FCC Class II Permissive Change Application Letter

Product name : HDMI Wireless Extender
FCC ID: 2ADXC-QAZWSXTX
Date of Grant: 01/02/2025
Model No.: LKV699KVM-V2.0-TX, LKV699-V2.0-TX, LKV677-V2.0-TX,
LKV677KVM-V2.0-TX,, LKV655-V2.0-TX, LKV655KVM-V2.0-TX

Change Contents: Replace the casing and only derive one prototype.

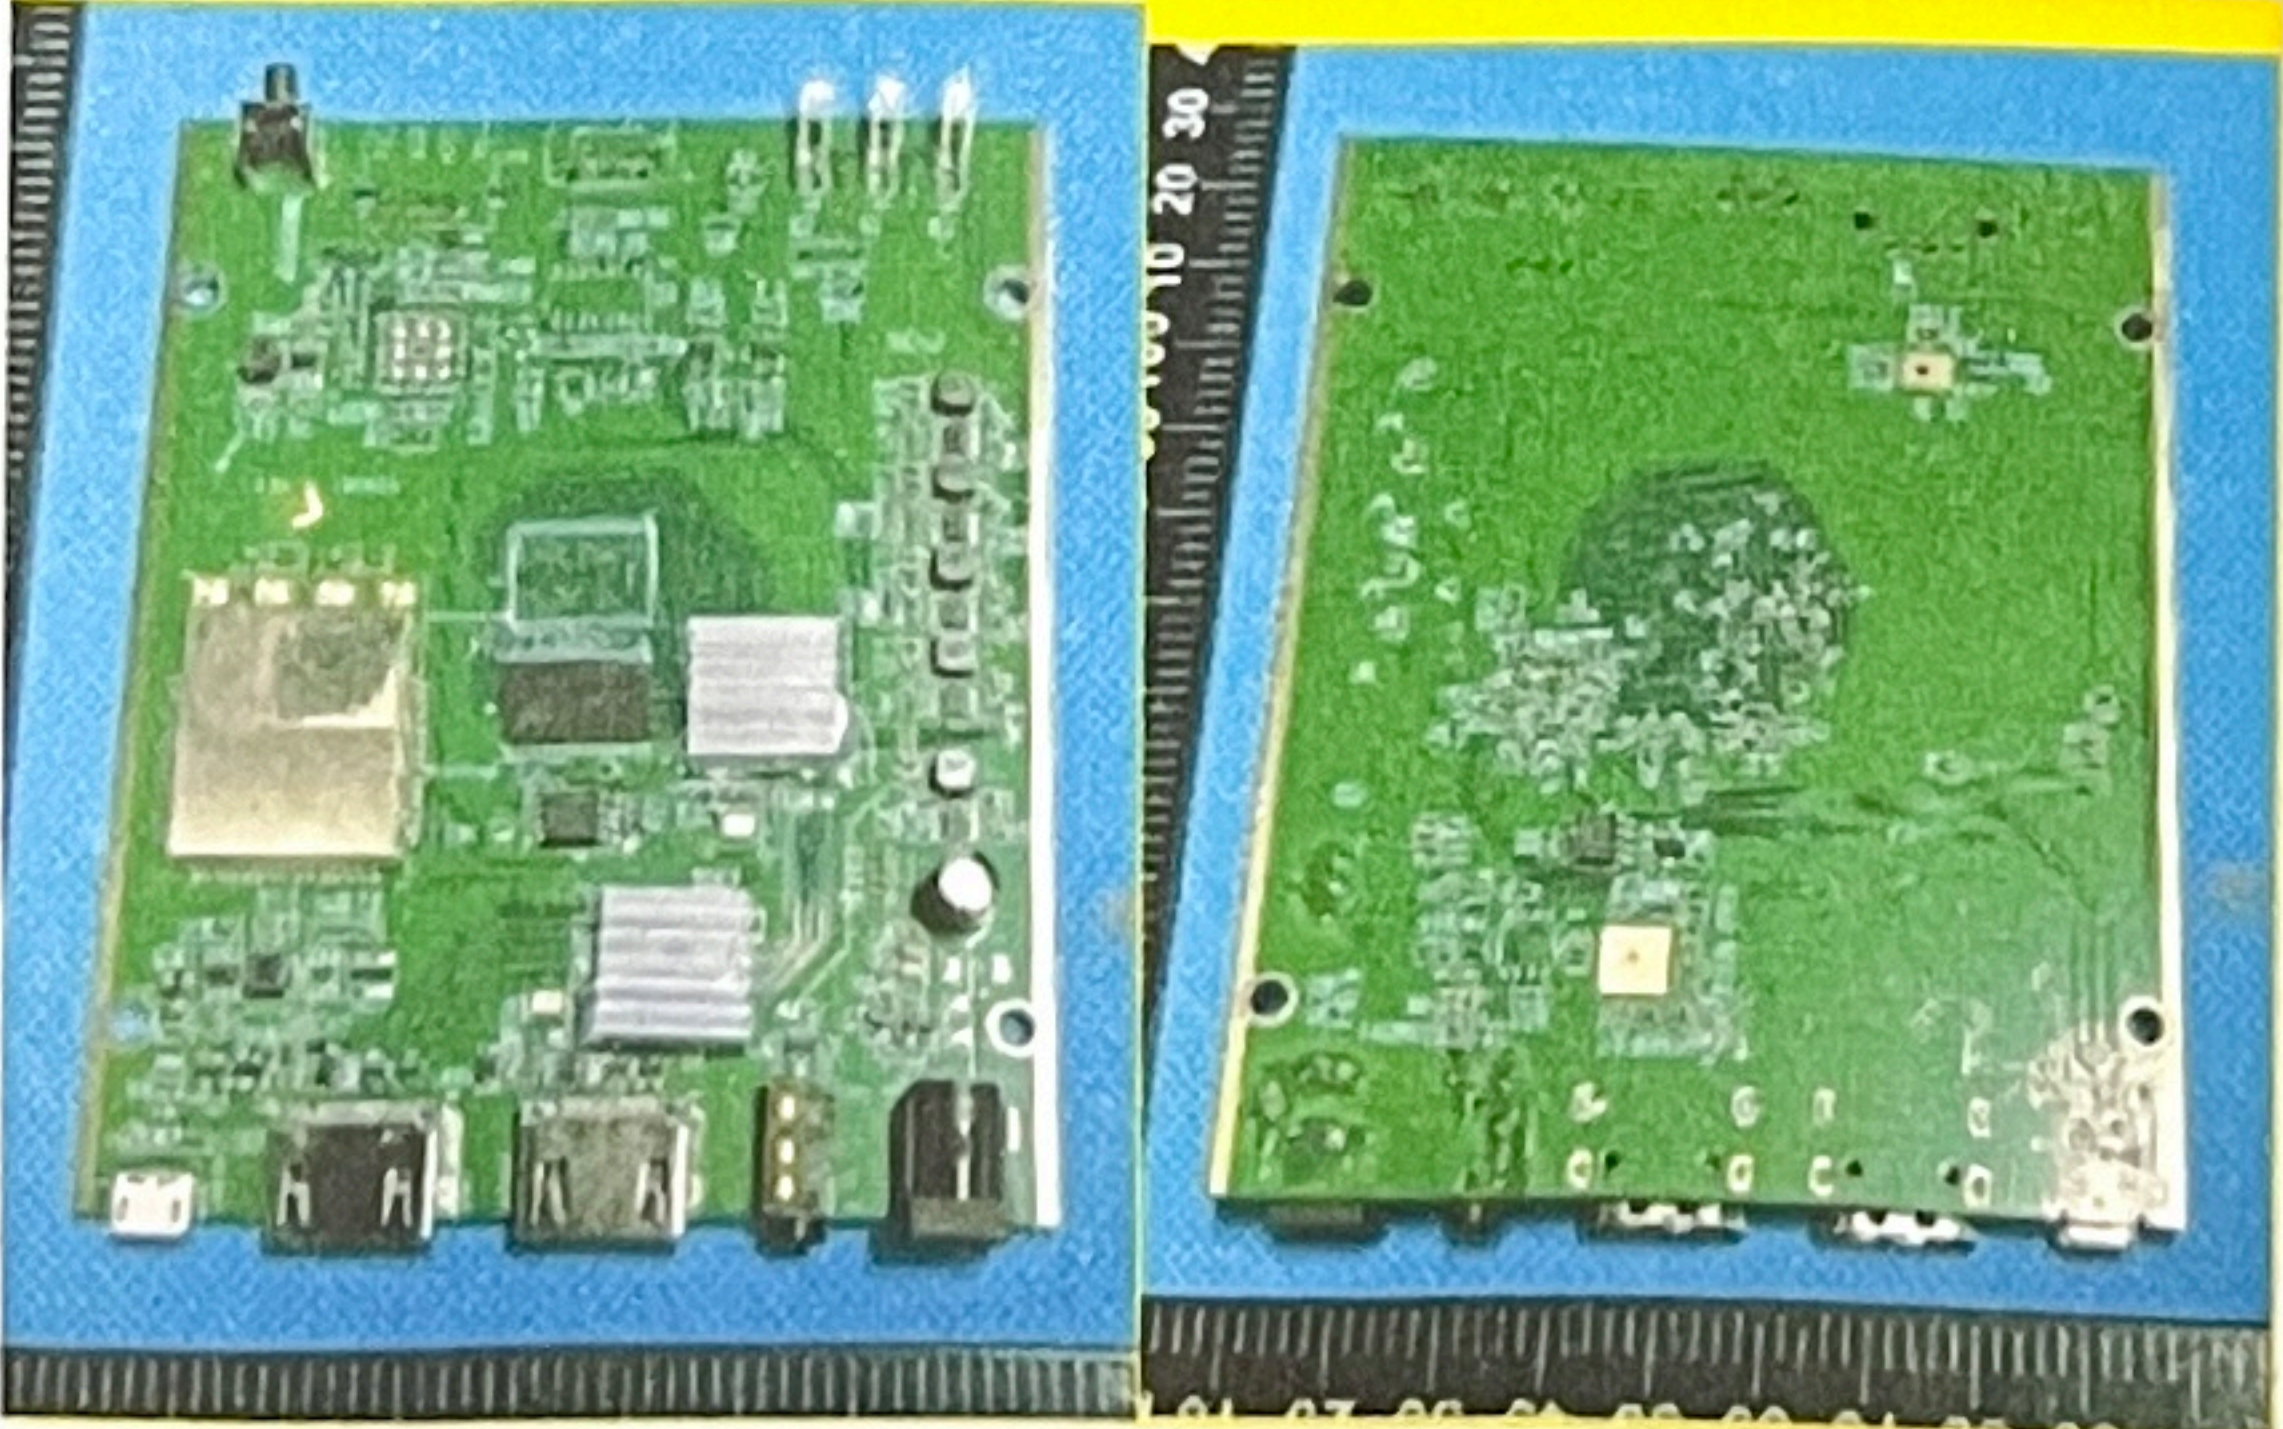
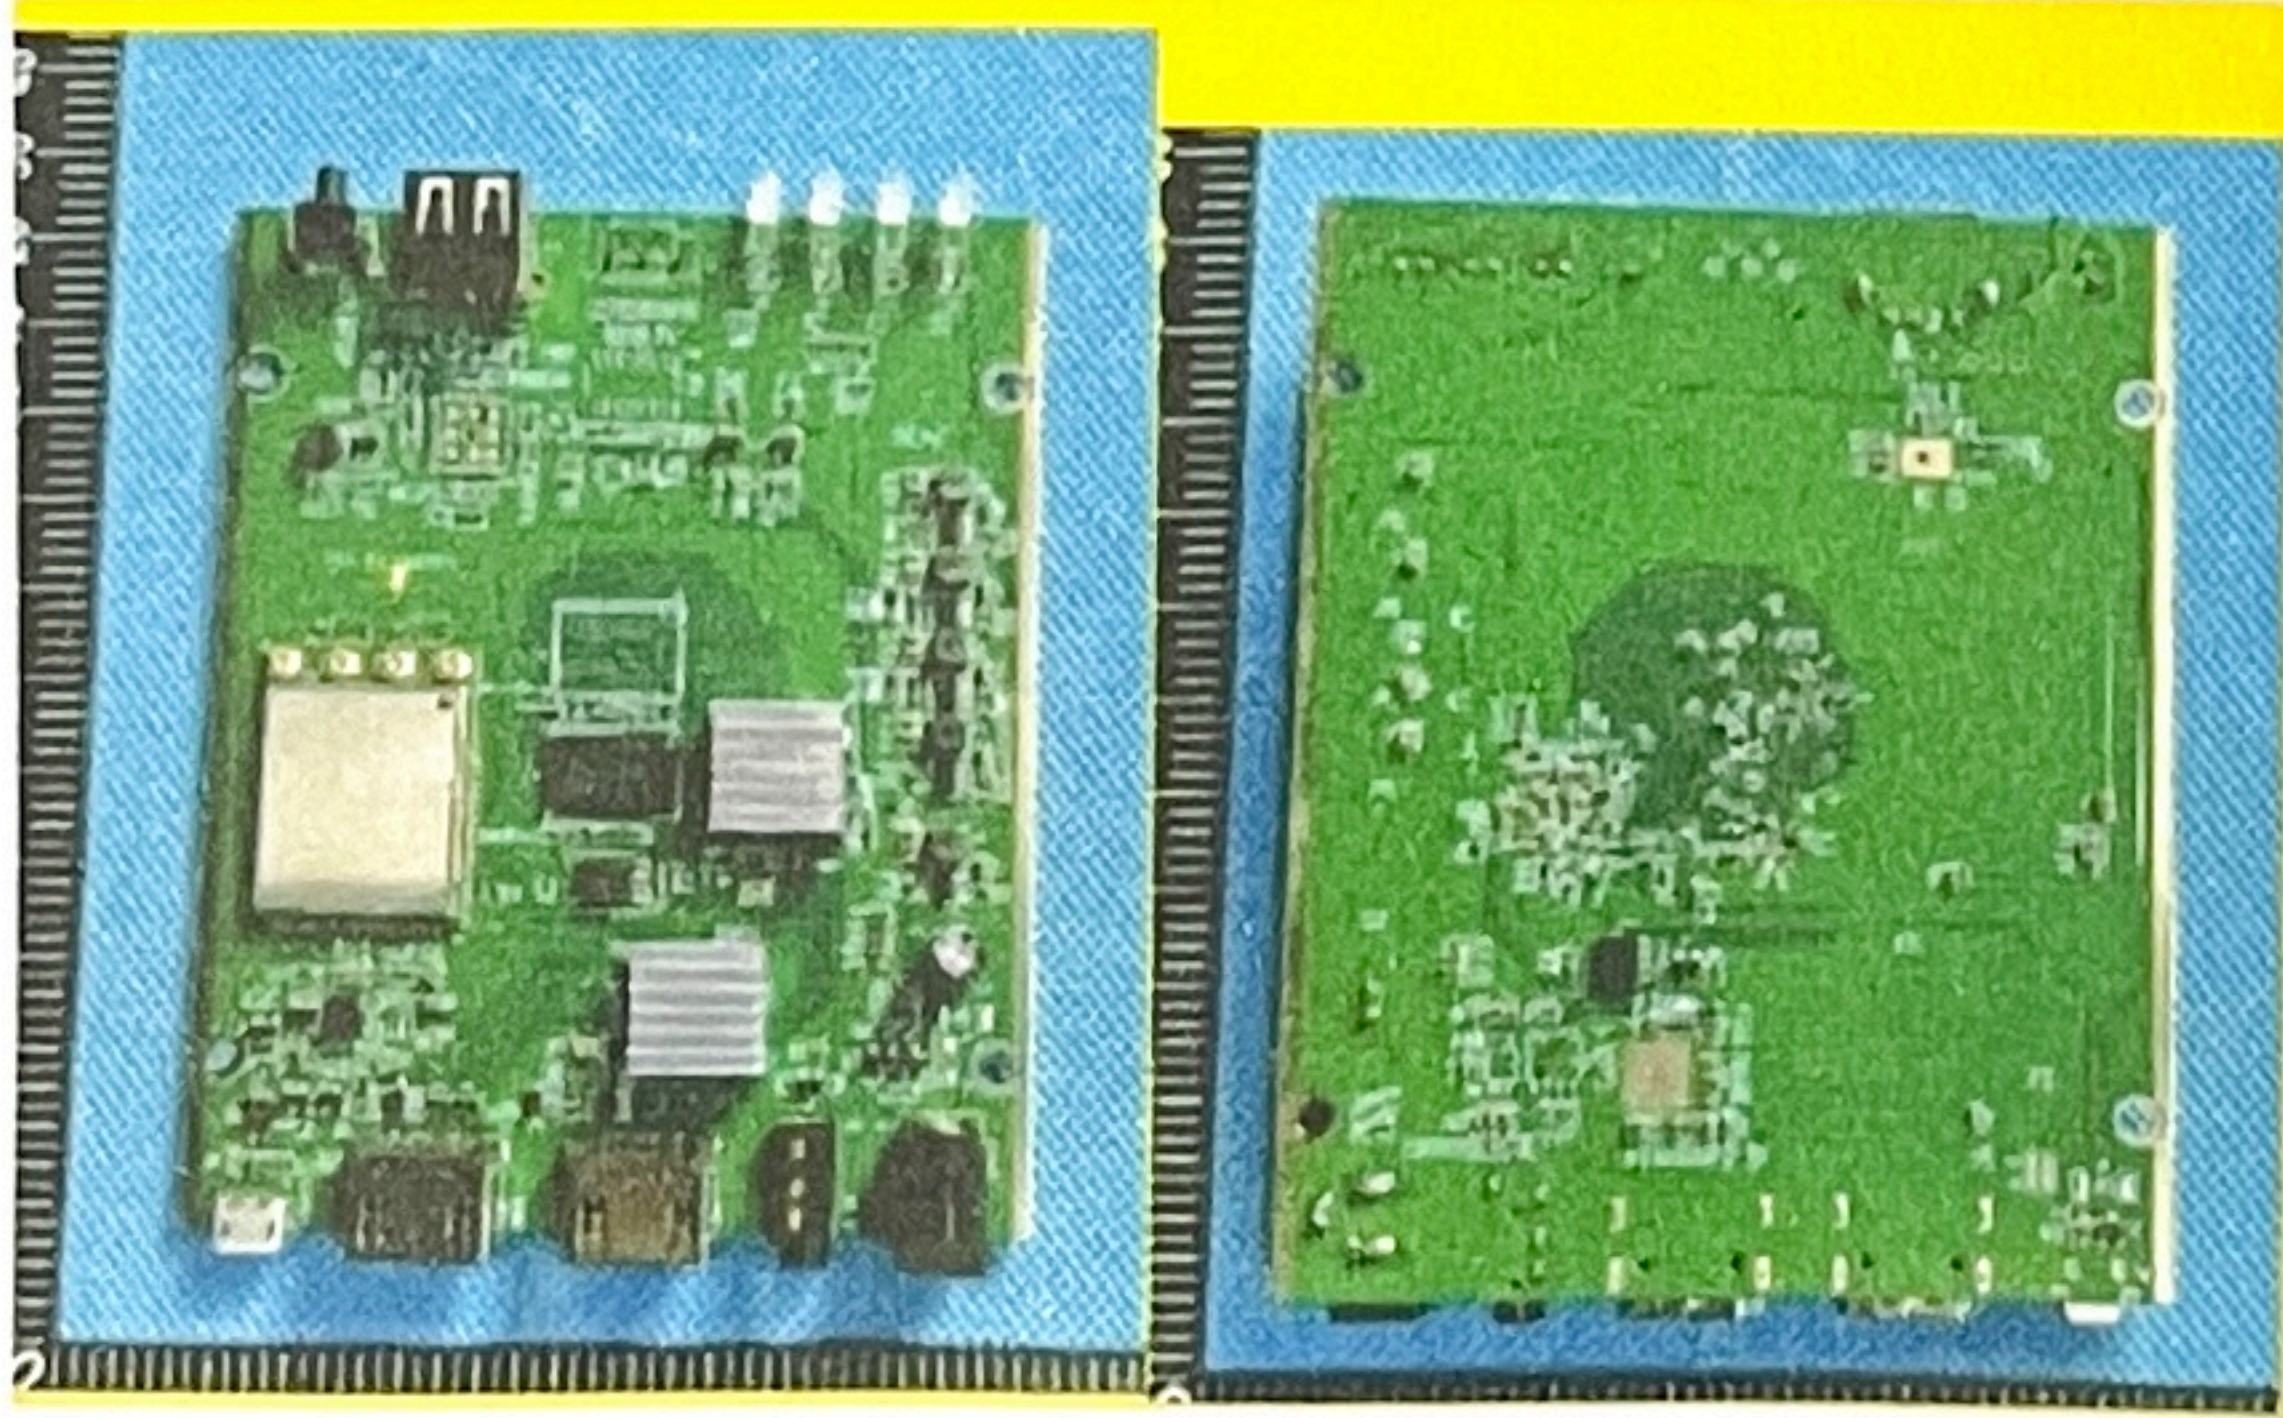
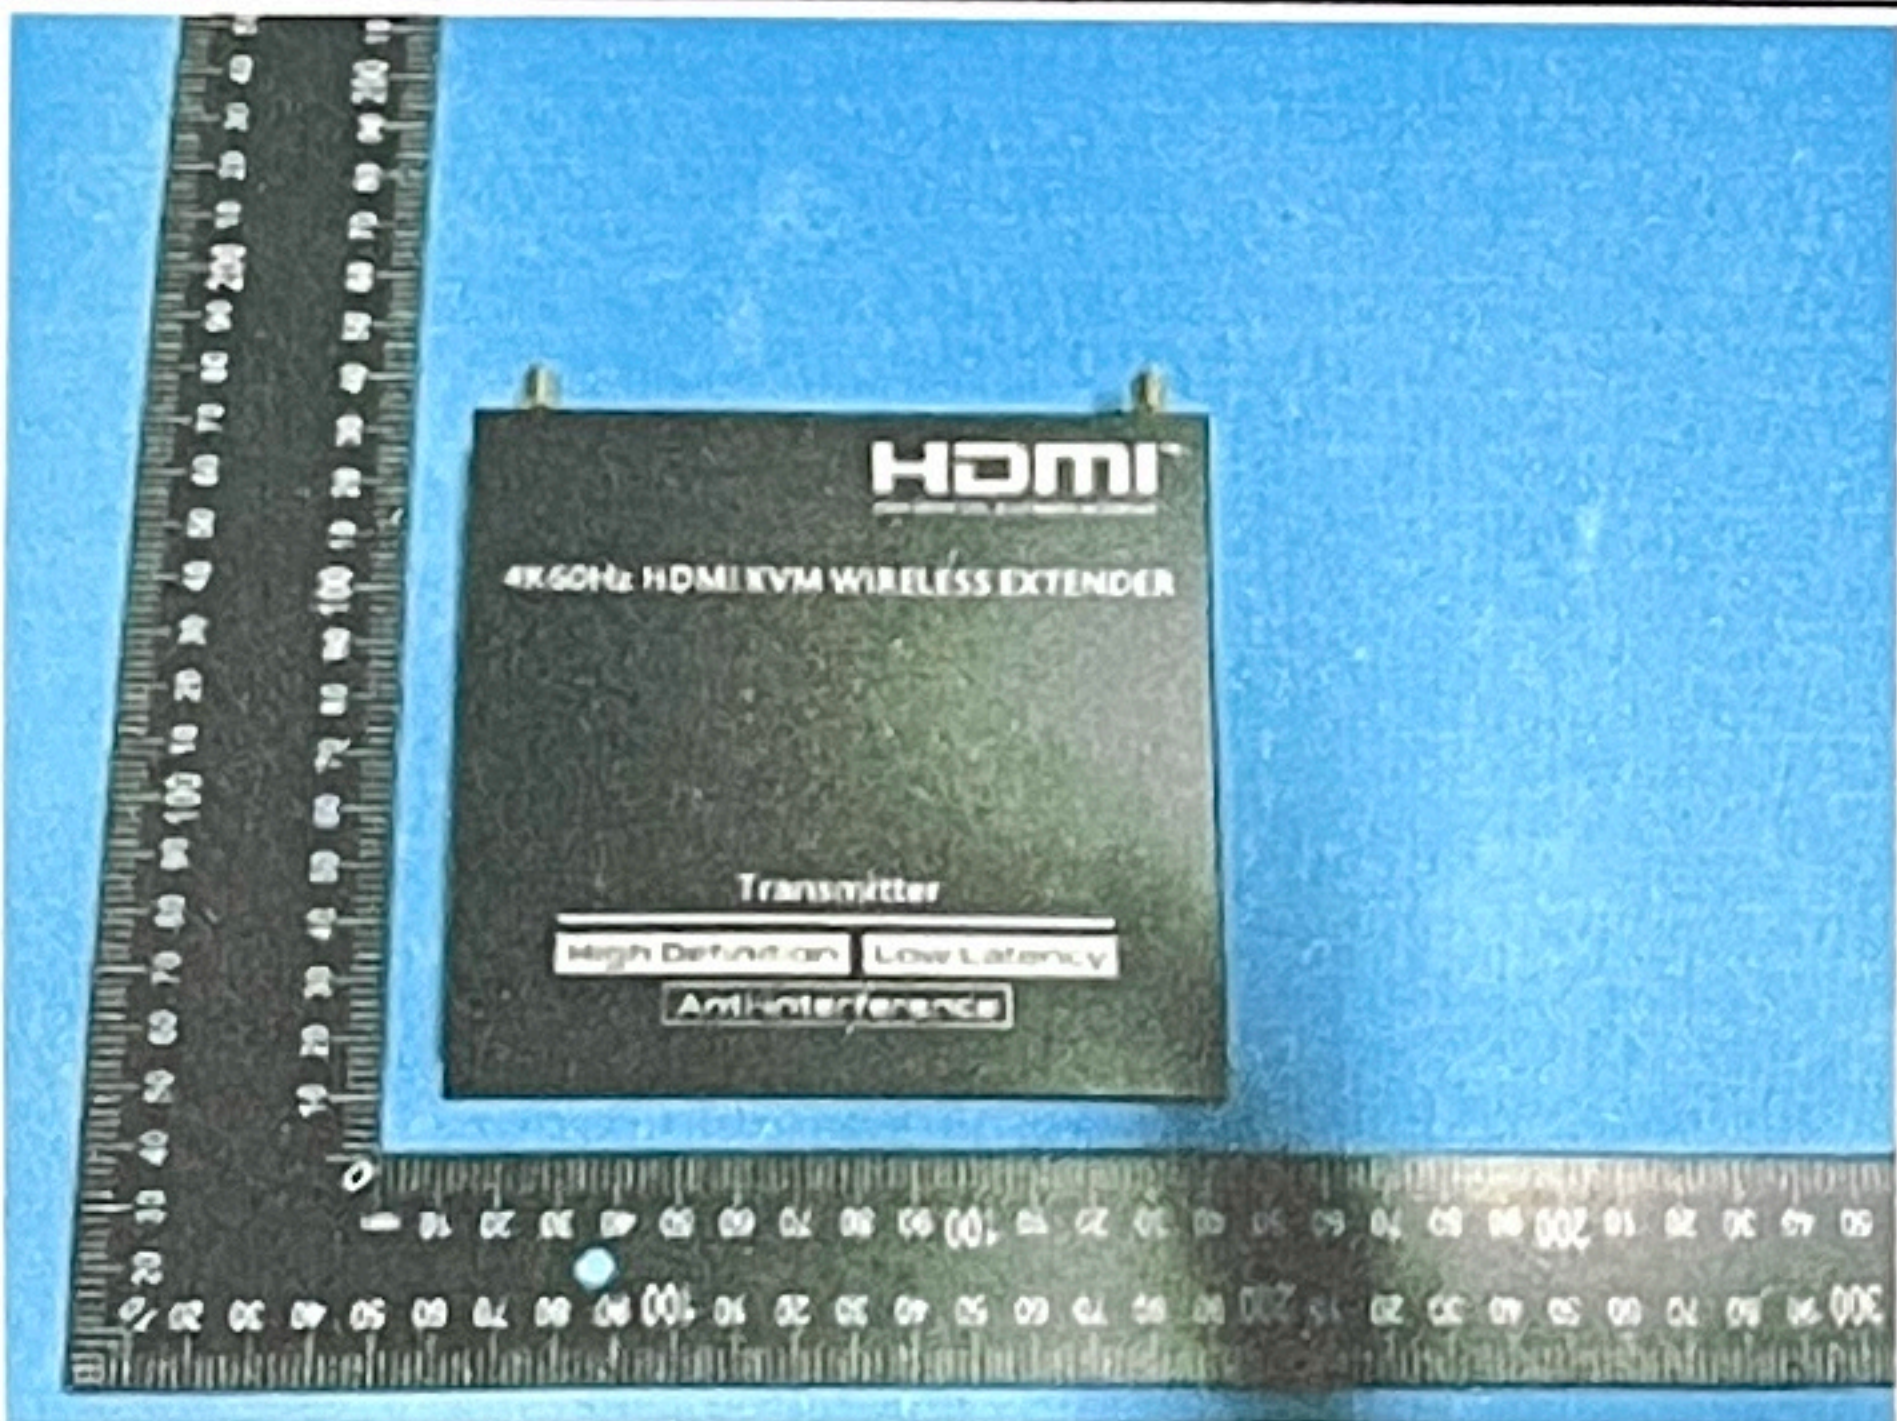
Location	Old PCB of FCC ID: 2ADXC-QAZWSXTX	New PCB of FCC ID: 2ADXC-QAZWSXTX
Product Appearance		
Previously, the shell material was iron, but now it is aluminum. There were originally two PCBA boards, but now there is only one. The change in the material of the casing will not affect the

dimensions of the product.
Modifications that do not change the fundamental RF characteristics and that do not degrade the unwanted emissions of the certified product, please refer to test report for more details; Modifications that do not change physical characteristics significantly. We attach new photographs to identify the modified product.
